Page, Re-commendation Chapter, Date of action	Corrigendum/Modification	New text																																																
(August 2008)	Information	Nominal values are in DIN 1054 and subsequently in EAU denominated as Design values. Nominal values are in the meaning of DIN EN 1990, values, which are not determined statistically, but based on experience or on physical conditions (DIN EN 1990, Ziff. 1.5.2.22). In DIN EN 1990 nominal values are handled as characteristic values, that means they are used in the design procedures corrected by partial safety factors. The practice in EAU (but also in DIN 1054) to set nominal values = design values is herewith withdrawn.																																																
p. VII, preface (Dec. 2005)	Corrigendum	„The incorporation of the partial safety factor concept of DIN 1054 called for a fundamental reappraisal of the methods of calculation and design for sheet piling structures contained in sections 8.2 to 8.4 and the methods of calculation for sheet piles dolphins contained in section 13.“																																																
p. 5, section 0.2.2.4.1 (July 2007)	Amendment : Adjustment of the partial safety factor to the 2nd

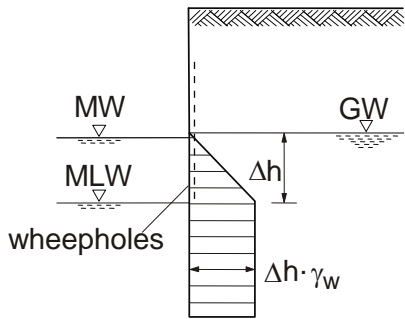
<p>p. 79, R 19, section 4.2 (Dec. 2007)</p>	<p>Corrigendum: Adjustment of the drawn description of MW in relation to GW for minor water level fluctuations.</p>	<table border="1" style="width: 100%; border-collapse: collapse;"> <thead> <tr> <th colspan="5" style="text-align: center;">Non-tidal area</th> </tr> <tr> <th style="width: 20%;">Situation</th> <th style="width: 25%;">Figure</th> <th colspan="3" style="width: 55%;">Load causes as per R 18</th> </tr> <tr> <td></td> <td></td> <th style="width: 15%;">1</th> <th style="width: 15%;">2</th> <th style="width: 15%;">3</th> </tr> </thead> <tbody> <tr> <td style="vertical-align: top;"> <p>1 Minor water level fluctuations ($h < 0,50$ m) with weepholes or permeable soil and structure</p> </td> <td style="text-align: center;">  </td> <td style="vertical-align: top; text-align: center;"> <p>$\Delta h = 0,50$ m</p> </td> <td style="vertical-align: top; text-align: center;"> <p>$\Delta h = 0,50$ m</p> </td> <td></td> </tr> <tr> <td colspan="5" style="text-align: center;"> <p>Figure R 19-1 Situation 1</p> </td> </tr> </tbody> </table>	Non-tidal area					Situation	Figure	Load causes as per R 18					1	2	3	<p>1 Minor water level fluctuations ($h < 0,50$ m) with weepholes or permeable soil and structure</p>		<p>$\Delta h = 0,50$ m</p>	<p>$\Delta h = 0,50$ m</p>		<p>Figure R 19-1 Situation 1</p>

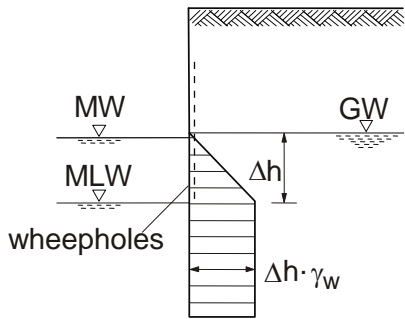
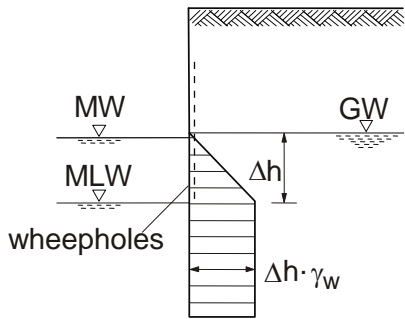
Tidal area																											
Situation	Figure	Load cases as per R 18																									
		1	2	3																							
<p>Figure E 19-2</p>																											
<p>p. 80, R 19, section 4.2 (Aug. 2010)</p>	<p style="color: red;">Inofficial (!) Corrigendum: Equation in fig. R 19-2</p>	<p style="color: blue;">Fig. R19-2, case 3a: $\Delta h = a + 0.30 \text{ m} + d$</p>
